**TOWN OF MOUNTAIN VILLAGE  
REGULAR DESIGN REVIEW BOARD MEETING  
AGENDA**

**THURSDAY SEPTEMBER 3, 2020 10:00 AM**

**TO:** Mountain Village Design Review Board  
**FROM:** John Miller, Senior Planner  
**FOR:** Design Review Board Public Hearing; September 3, 2020  
**DATE:** July 23, 2020, *Updated August 21, 2020*  
**RE:** Staff Memo – Initial Architecture and Site Review (IASR) Lot 630

Grading  
and  
Drainage Plan  
and  
Utility  
Plan

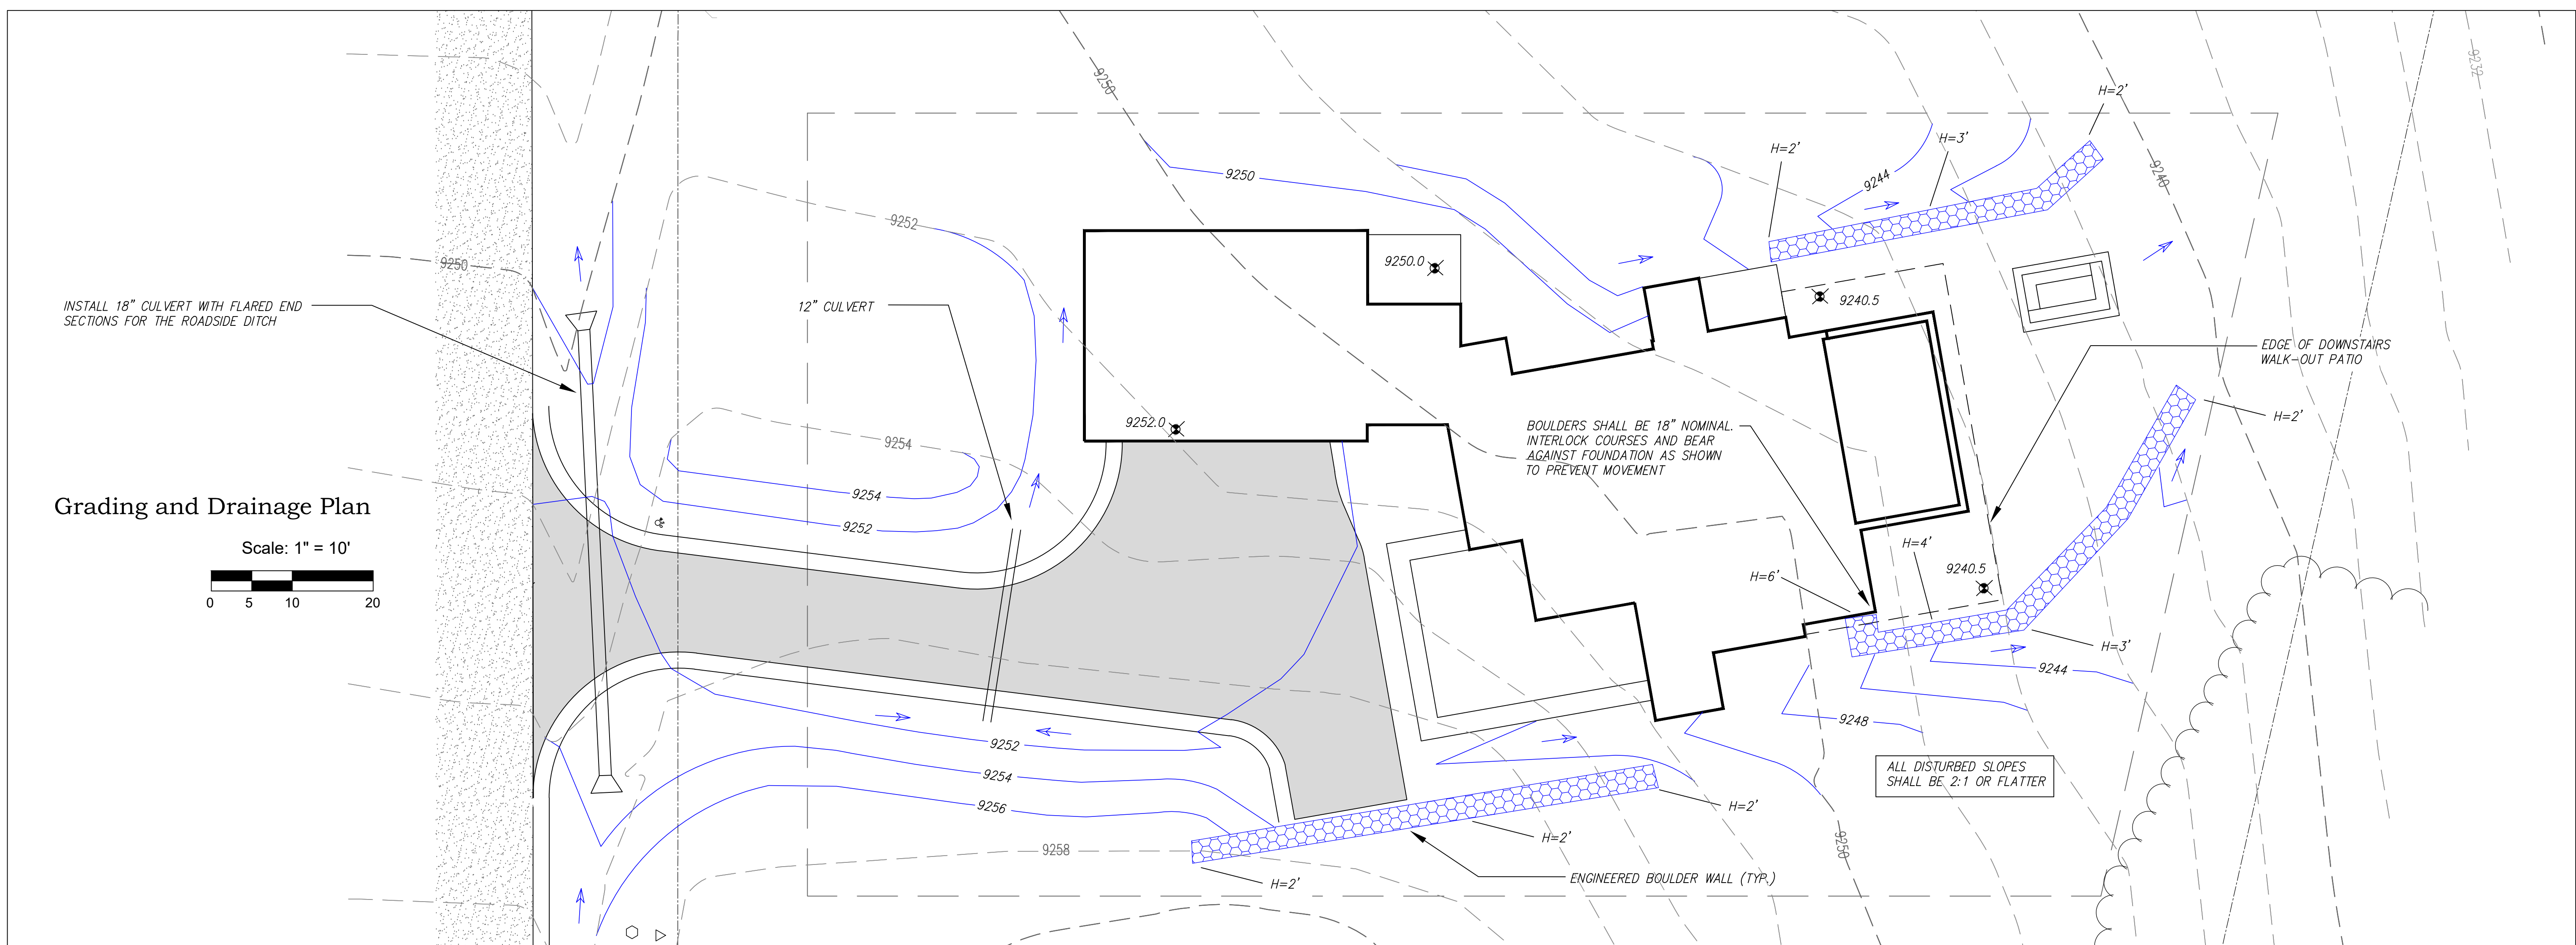
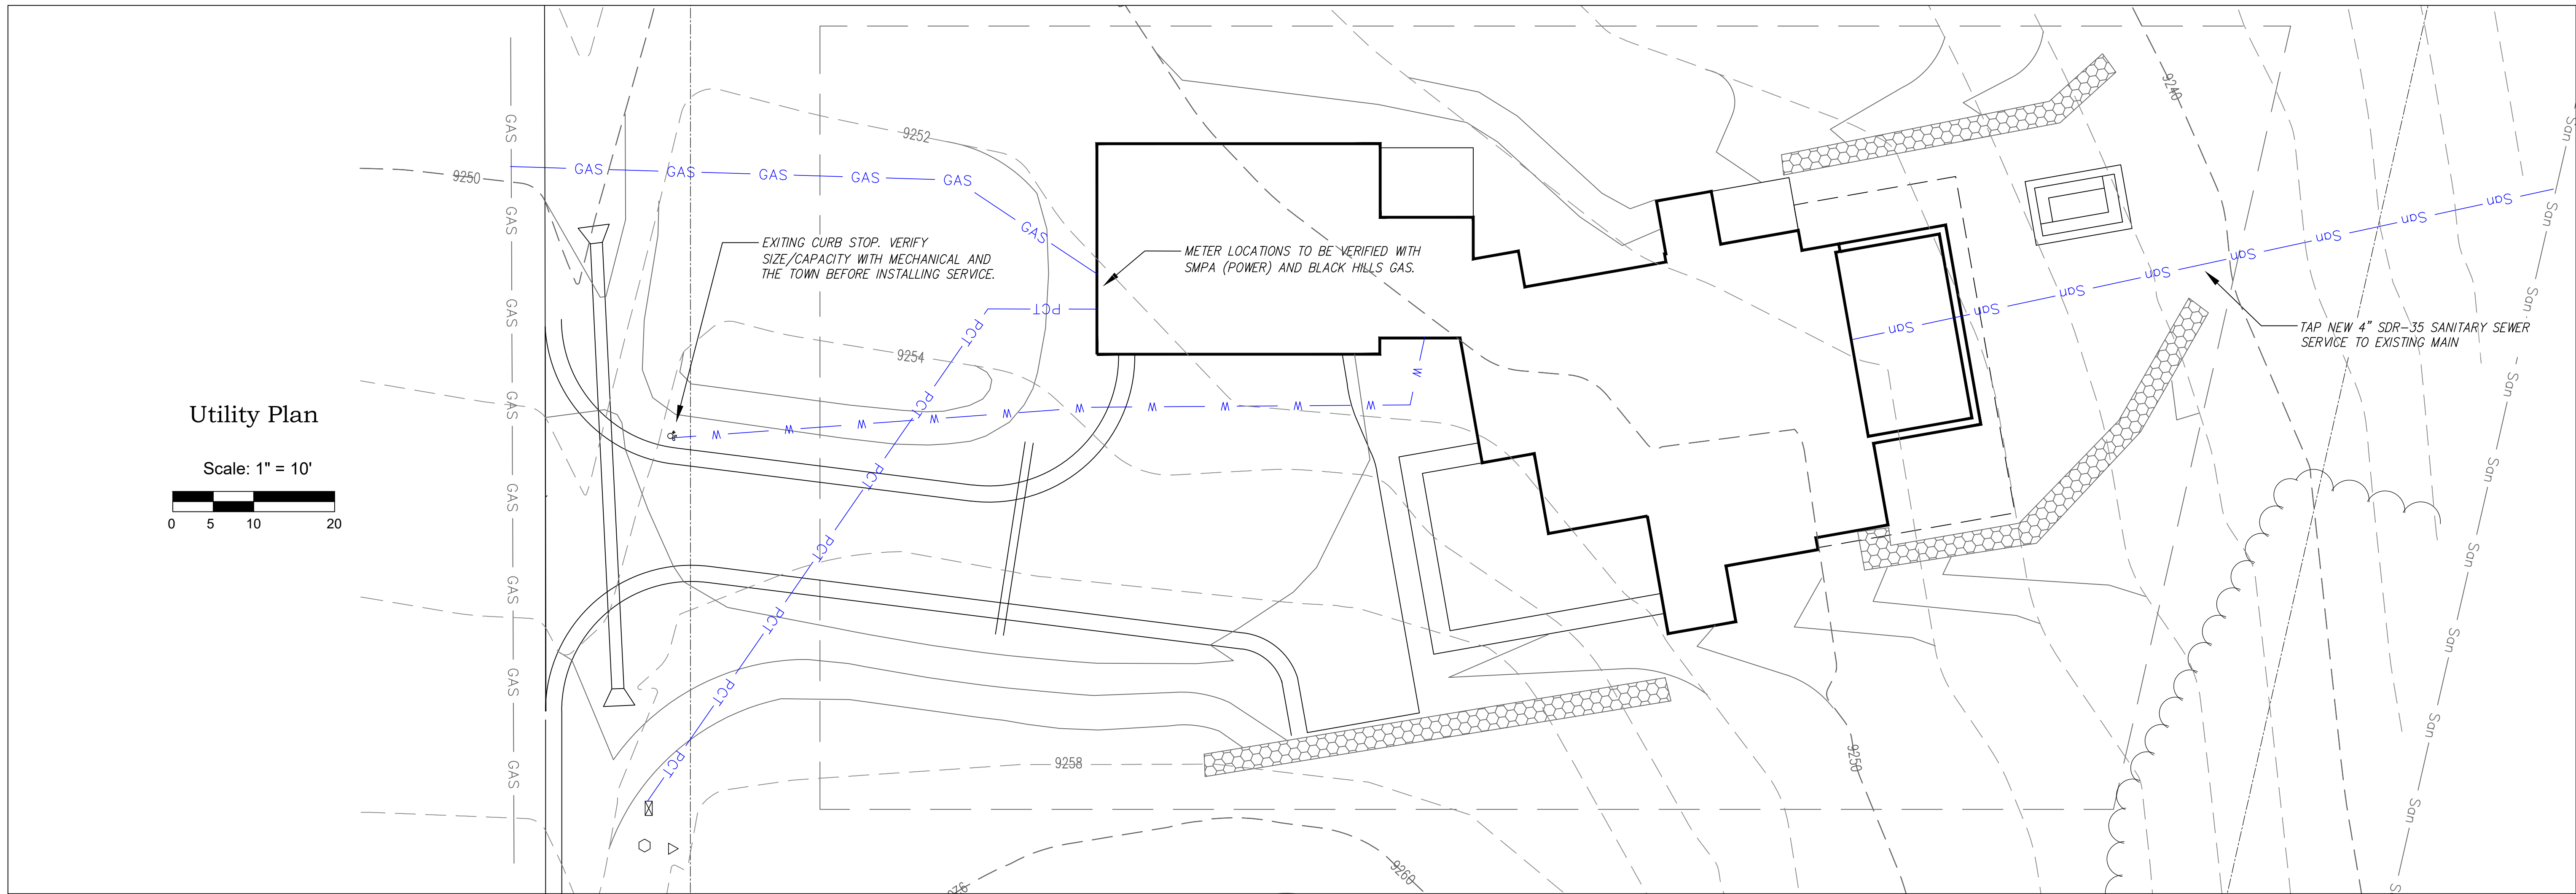
*Staff: The applicant has provided a grading and drainage plan documenting disturbed areas, cuts, fill, final slopes adjacent to the home, stormwater design including positive drainage from proposed home.*

*Staff: All utilities are currently located within the Double Eagle Drive roadway and will only require connections from the road to the home. The applicant shall work with the Public Works Director before the final review to determine the specific locations of the connections for the home. The plan set shows the proposed connections and the locations of the proposed utilities based on field research.*

- 4) Prior to the issuance of a building permit, the applicant shall field verify all utilities and submit a revised utility plan to the public works director identifying the location of utilities and connection points.

Phase  
**PROPOSED SITE PLAN**

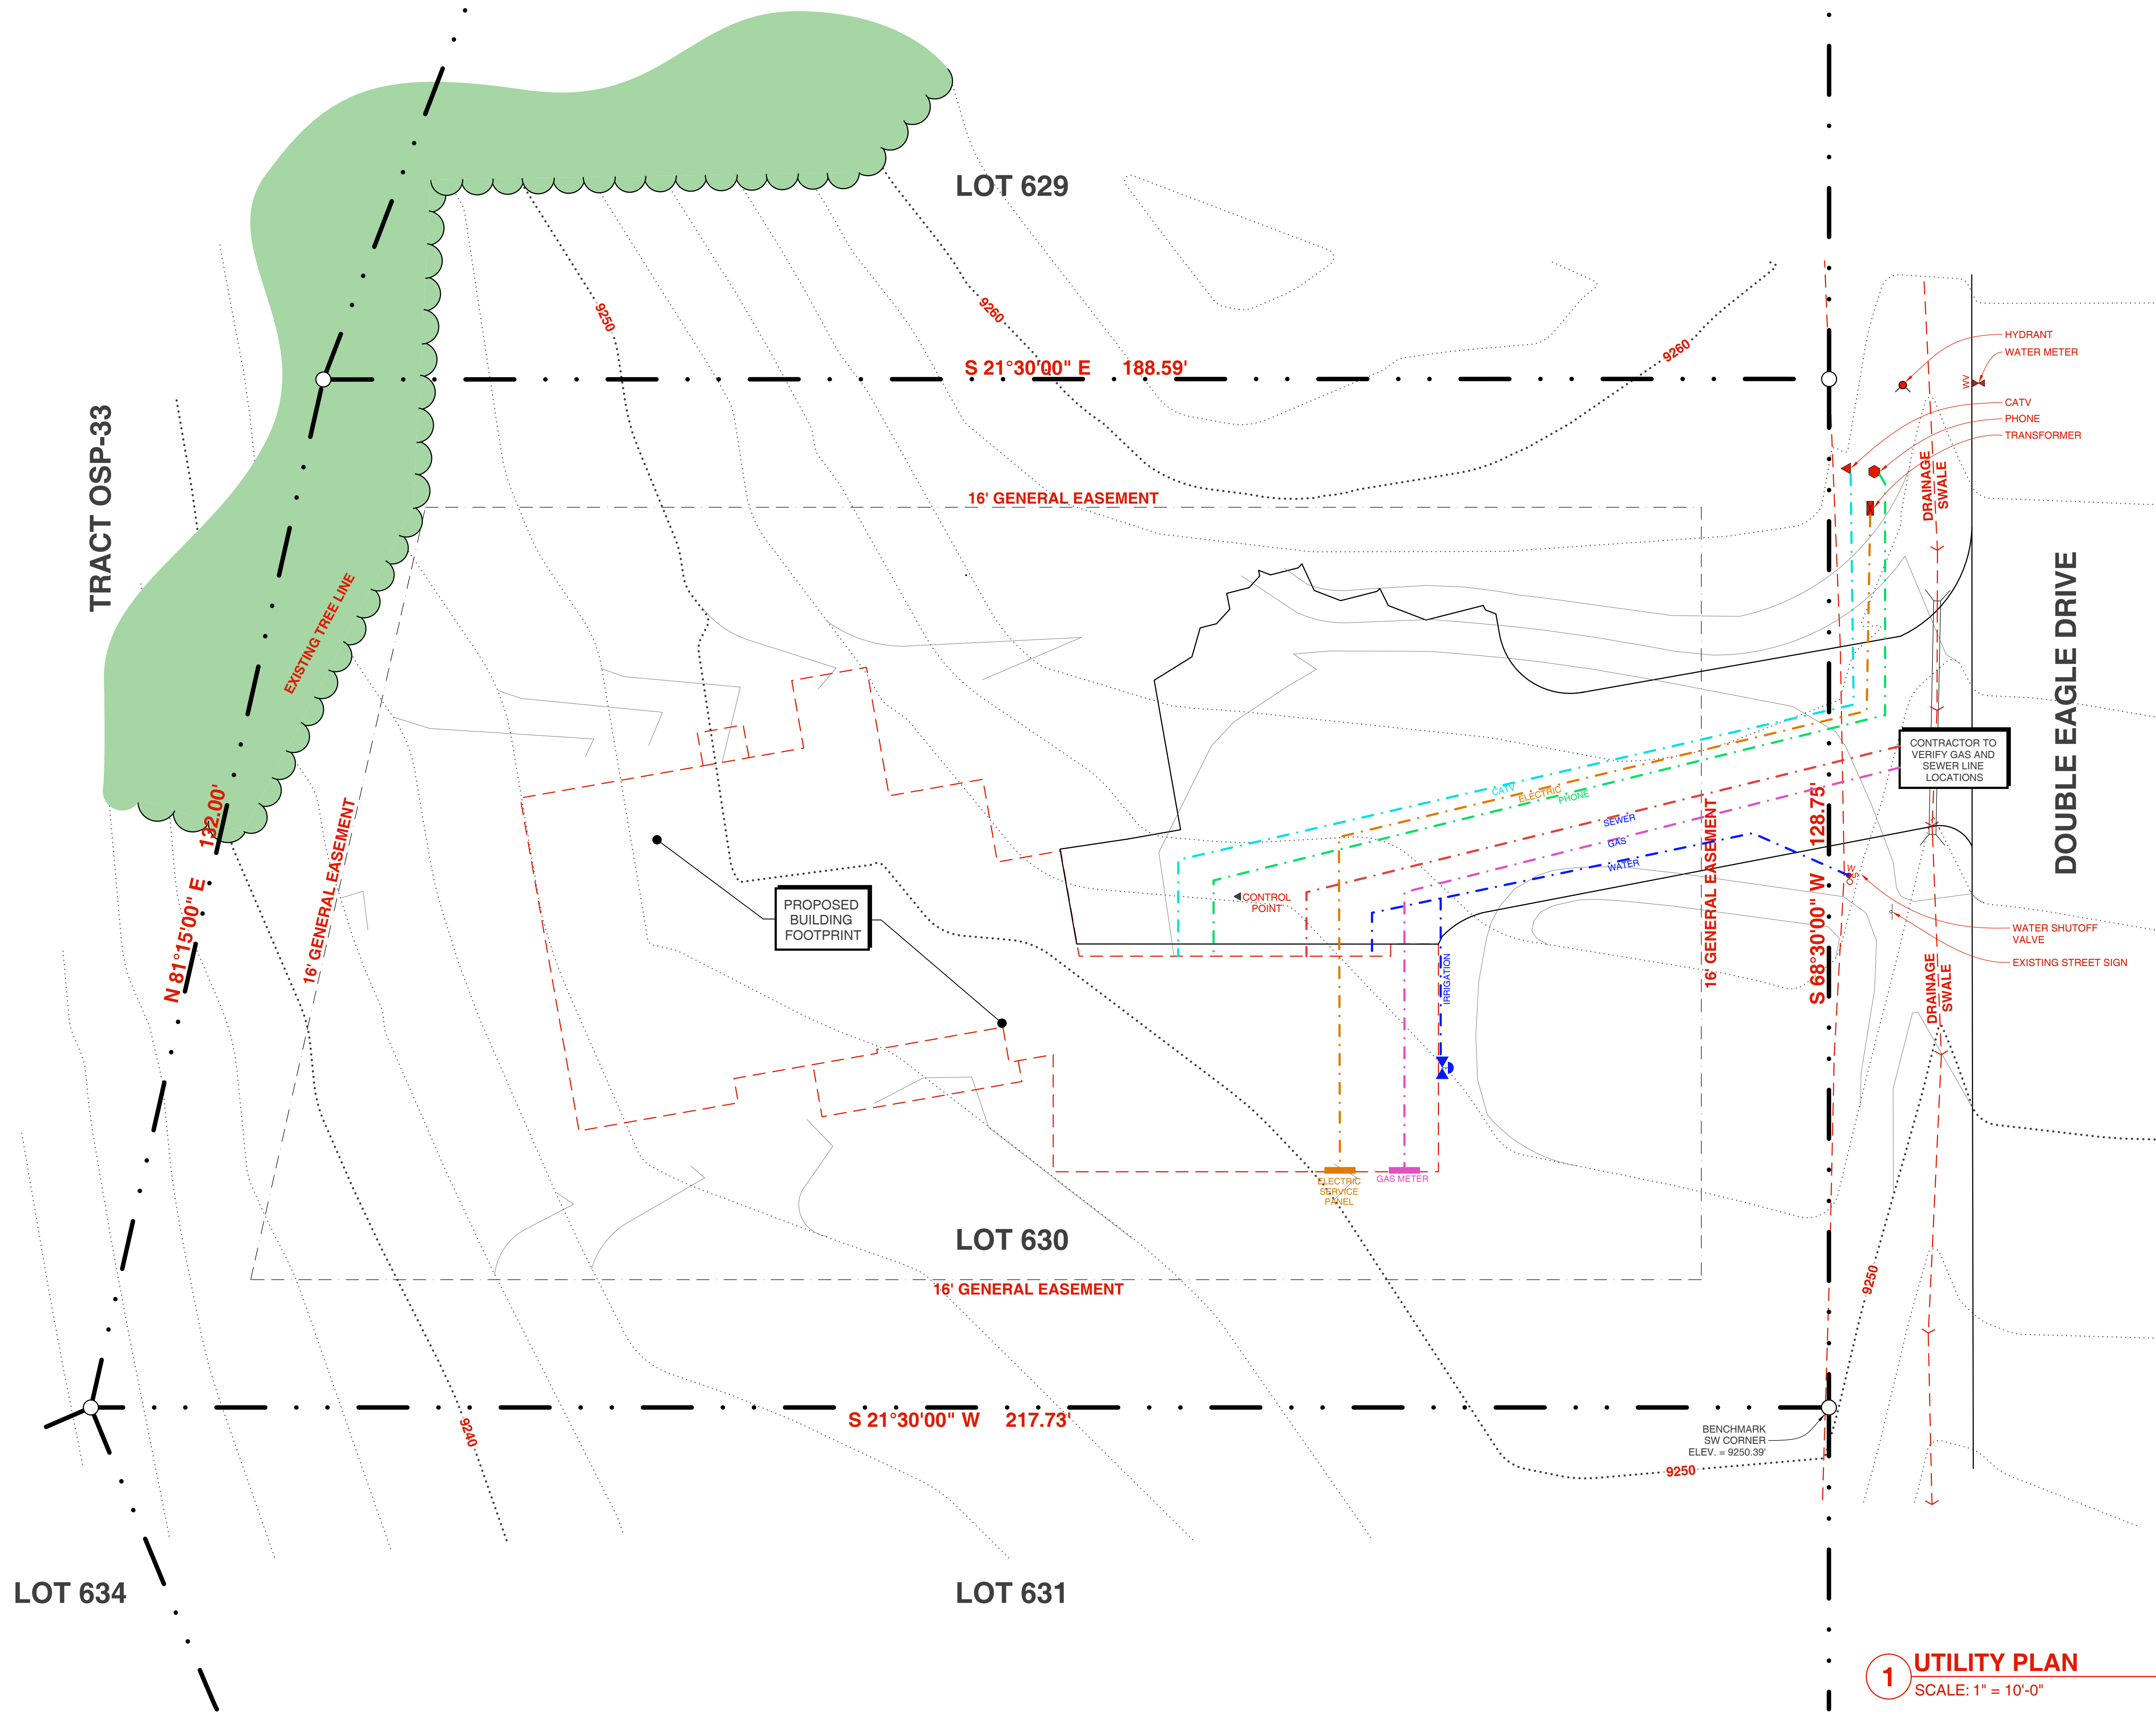
*Staff: The CDC requires all single-family developments to provide two interior and two exterior parking spaces. The applicant has revised their plans from the July hearing to demonstrate that the required 2 interior and 2 exterior spaces can be accommodated.*

- 3) Prior to the submittal for a Final Architectural Review, the applicant shall revise their parking plans to demonstrate the ability to provide exterior parking on Lot 630.
